Attachment 4 – Precinct-specific issues raised in submissions Amendment C231 – Queens Parade

This table summarises comments made in submissions which are specific to the five precincts in Queens Parade eg suggested changes to heights or zoning.

Precinct 1 – Brunswick Street Precinct

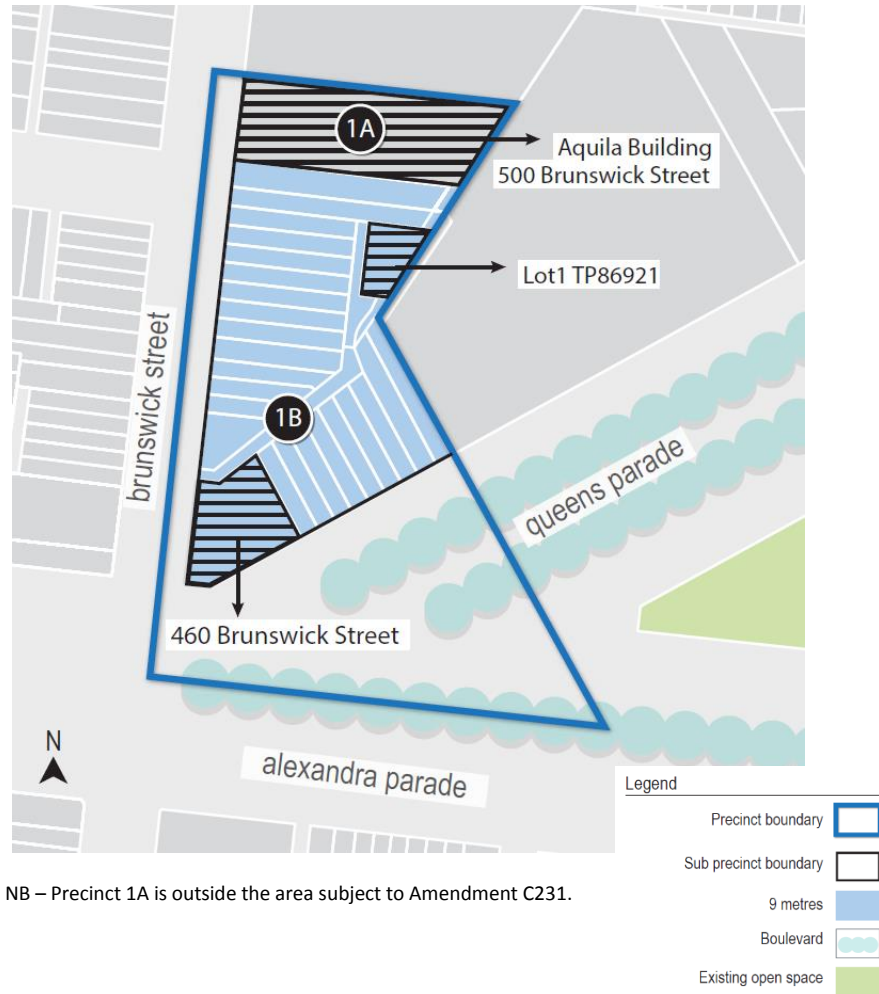
- Proposed height in C231 – 9m (mandatory) adjoining 460 Brunswick Street (corner Queens Parade) and on land known as Lot 1 on Title Plan TP806921. 9m (preferred) applies elsewhere in the precinct.
- Alternative suggested by submitters:
 - No alternative height suggested. Submitters supported the proposed controls ie maximum mandatory 9m / 3 storey height but wanted a mandatory control across the precinct.
 - See note on page 1 re multi-precinct submissions.

- Precinct 1A is not part of the amendment (outside the DDO).
- Two submitters commented that the Aquila Building at 500 Brunswick Street (an apartment building of six storeys to the immediate north of Precinct 1B) is a prime example of failed planning controls, particularly in terms of overlooking.

- Submitters supported mandatory height controls for Precinct 1.

Precinct 2 – Boulevard Precinct (cont.)

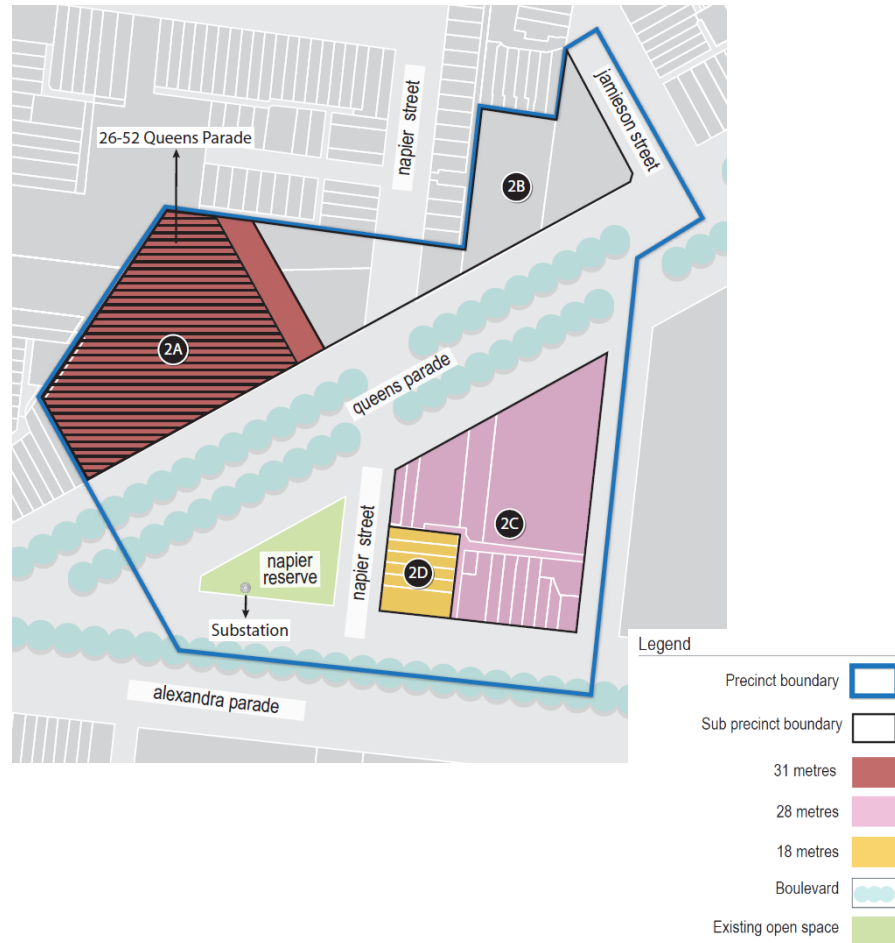
- Proposed height in C231 - 31m (mandatory)
- Alternative heights suggested by submitters:
 - Up to 18 metres / 5 storeys
 - 31m as recommended in the Hansen report but height limit to be mandatory.

- Proposed height in C231 - Land largely in MUZ and outside the proposed DDO. No height control applies in MUZ or is proposed in the amendment.
- Alternative height:
 - 3 storey (9m) as recommended in the Hansen report but height limit to be mandatory.

- Proposed height in C231 - 28m (preferred)
- Alternative heights:
 - Maximum building height should be 8 storeys (as the recent approval of 34.8 metres demonstrates). [No height in metres was suggested.] Hansen's recommended 28.5 metres is too low as this is a Commercial 2 Zone (C2Z) and commercial developments need higher floor to ceiling heights.
 - Other submitters supported the 28.5m height proposed by Hansen but submitted the height limit should be mandatory.

- Proposed height in C231 - 18m (preferred)
- Alternative height:
 - Supported the 18m height recommended in the Hansen Report (and in the amendment) but the height should be mandatory.

- Proposed setback in C231 - Apply B17 side and rear setbacks from Res Code.

- Alternative suggested by submitter - B17 applies to multi-dwelling developments up to 4 storeys in height. This site is within a Commercial 2 Zone (C2Z) that prohibits dwellings and encourages commercial development. B17 setbacks are not appropriate on this site and should be removed. [No alternative proposed.]

- As proposed in C231 - No change to the planning scheme proposed. Substation not in Heritage Overlay (HO) and identified for inclusion.
- Alternative suggested by submitter - Non-contributory grading given to the electrical substation on Napier Reserve by GJM Heritage is an error and should be reconsidered for inclusion in the Heritage Overlay.

Alignment of permanent DDO with interim DDO

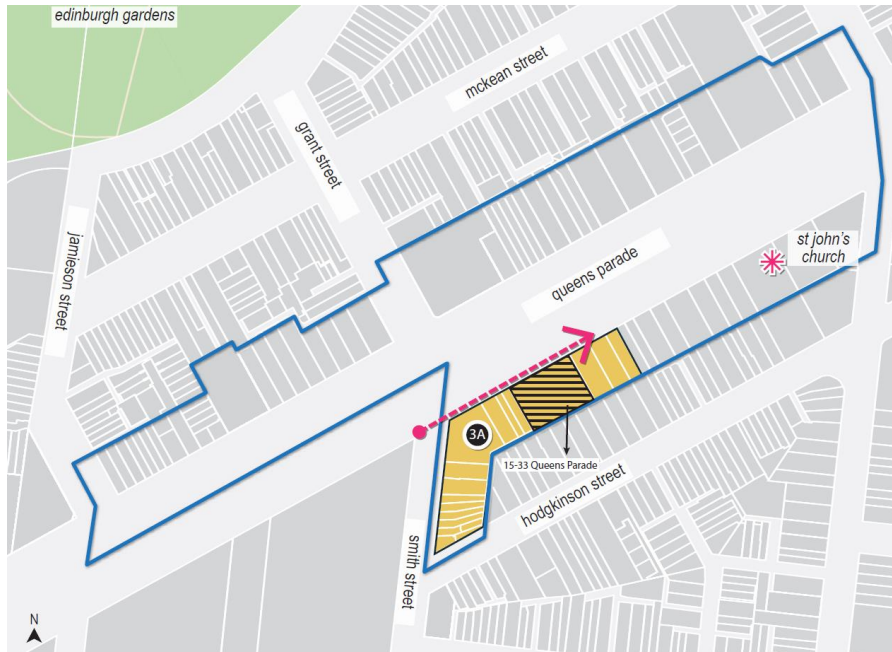
- Some submitters highlighted the VCAT case at 26-52 Queens Parade (hatched on map) and wish to ensure the wording of permanent controls is identical to interim controls.
- They noted the meaning of each word in the controls was subject to detailed scrutiny at the hearing.

7-11 Queens Parade

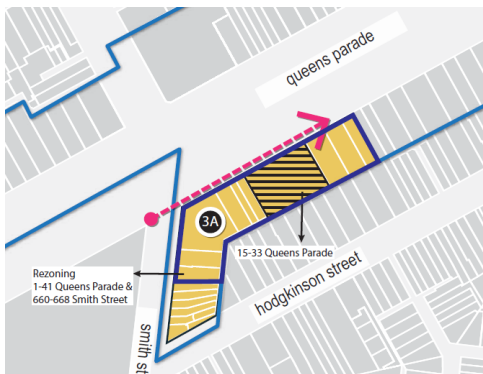
- Proposed in C231 - Change in grading of 7-11 Queens Parade from contributory to non-contributory
- Alternatives -
 - One submission objected to the proposed particular for 9-11 Queens Parade. Even though 9-11 Queens Parade is surrounded by non-contributory buildings, they 'read as part of the heritage precinct'. First floor is largely intact.

Precinct 4 – Activity Centre Precinct

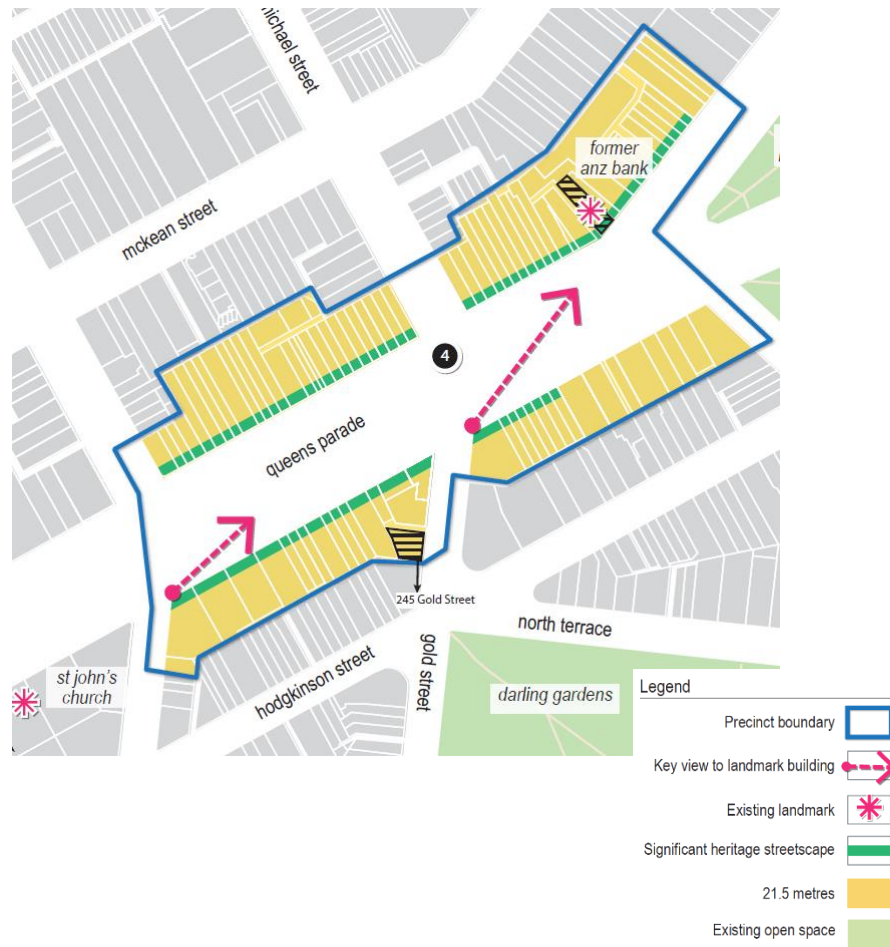
- Proposed height in C231 – 21.5m (mandatory)
 - One submitter supported the 6 storey height.
 - The rest expressed strong feelings about the proposed height – a large majority said 6 storeys was too high. Eg “beyond the pale and intolerable.”

- Alternatives suggested by submitters:
 - Majority view was that 4 storeys was appropriate.
 - However a significant minority suggested a 3 storey maximum.

- Specific concerns were also raised about the 1:1 visibility ratio (overall height to street wall height). Submitted a 1:1 ratio would allow an 18 metre height, yet the DDO specifies 21 metres (a ratio of 1.2:1).

127-129, 141, 280-356 (up to 20 shops), 324, 330, 336-338, 370 & 390 Queens Parade

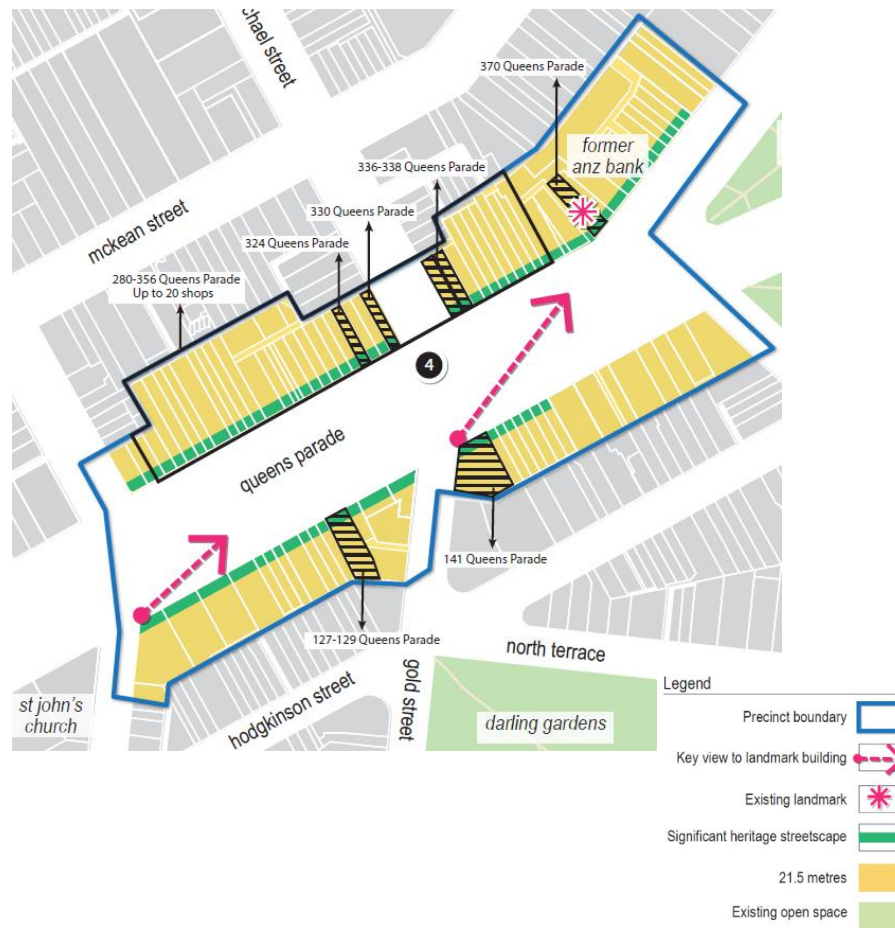
- Proposed - 6m setback
 - Submissions referred to inadequate setbacks and feared facadism would result.
- Alternatives:
 - Fewer submissions suggested an alternative setback compared to those who had a view on height.
 - Alternatives included:
 - 8 metres (as recommended by Hansen in February 2017)
 - 10 metres (Some that suggested 10m reminded Council of its resolution of 22 November 2016 – see height above)
 - 12 metres.

- Proposed - No changes were proposed to the gradings of the above properties excepting 304, 312 & 316 Queens Parade.
- Alternatives:
 - Approximately six submissions requested changes to the heritage grading for 127-129, 141, 280-356 (up to 20 shops), 324, 330, 336-338, 370 and 390 Queens Parade.
 - Submitters were concerned that the existing grading was insufficient to provide the level of heritage protection the buildings warranted. They requested Council review the grading of the properties and include them as individually significant properties within the Heritage Overlay.

Precinct 5 – North Eastern Precinct

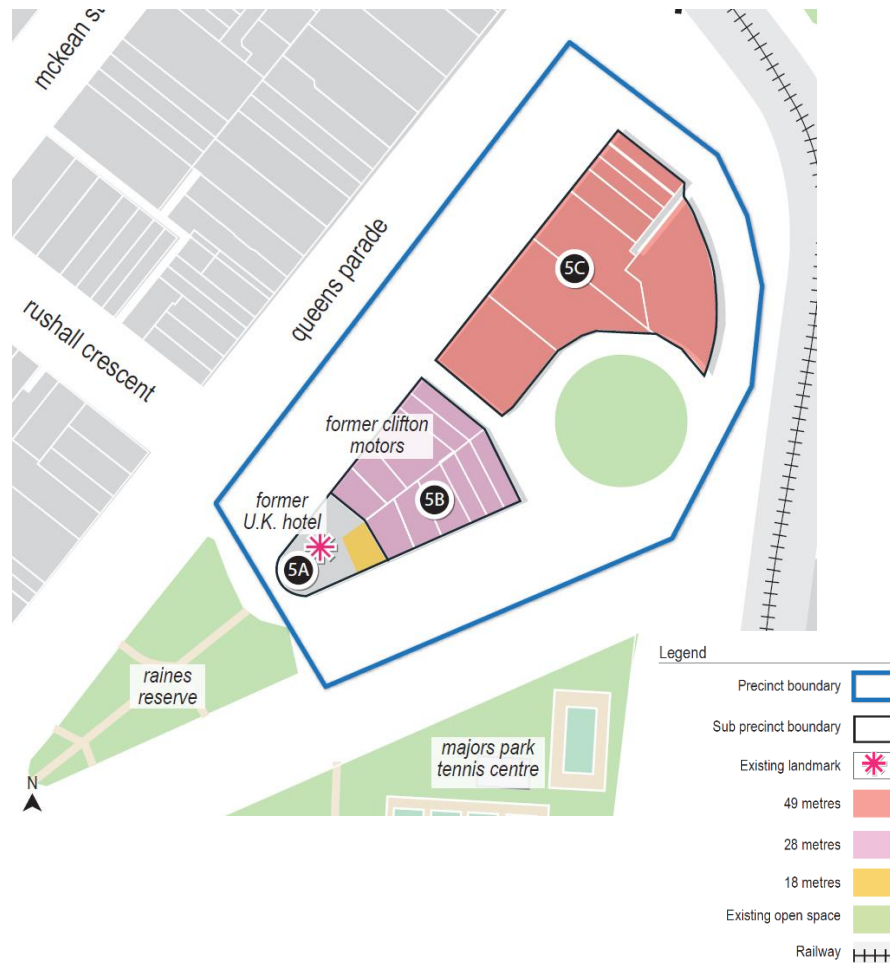
- Proposed height in C231 – 18m (preferred)
- Alternative suggested by submitters - No higher than 11 metres (3 storeys). Height should be mandatory.

- Proposed height in C231- 1:1 heritage street wall to new built form at Clifton Motors and 203 Queens Parade, 28m elsewhere (preferred)
- Alternatives - 11 metres on Queens Parade and 18 metres on Dummett Crescent. Height should be mandatory.

- Proposed height in C231- 49m (preferred)
 - Current building of 10 storeys, and 12 storeys building under construction already loom over Queens Parade and surrounding streets.
- Alternatives:
 - 8-10 storeys with significant setbacks to protect the precinct from greedy developers.
 - Maximum height should be 10 storeys.
 - The highest built form should be mid-block (current built form to be the maximum height). Heights should be similar or reduce at the north and south ends of this block.
 - 43m or 14 storeys (mandatory) should be required. 43 metres still represents the highest building height in Queens Parade. 43m is extremely generous.
 - Ensure that higher built form is not permitted on the corner of Hoddle Street and Queens Parade.

434-438 Queens Parade and Mayors Park

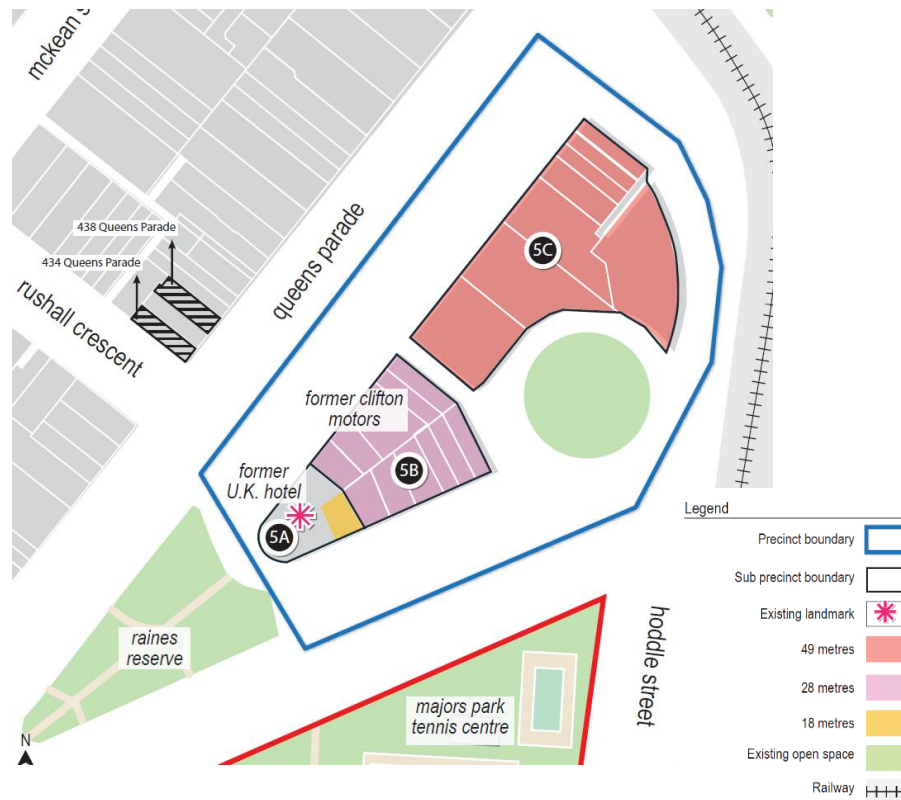
- Proposed street wall in C231- 35m street wall height (preferred)
 - 35m is too high
- Alternative - 18m is more appropriate.

- Proposed setback in C231– 6m at Clifton Motors (mandatory), 6m elsewhere (preferred)
- Alternative – Make the upper level setbacks mandatory.

- Proposed – Mayors Park is not within a Heritage Overlay and has no grading. 434-438 Queens Parade is within HO330 and graded 'individually significant.' Both sites are outside the boundary of the amendment area.
- Alternative - One submission said Council should review the grading of 434-438 Queens Parade and grading of Mayors Park.
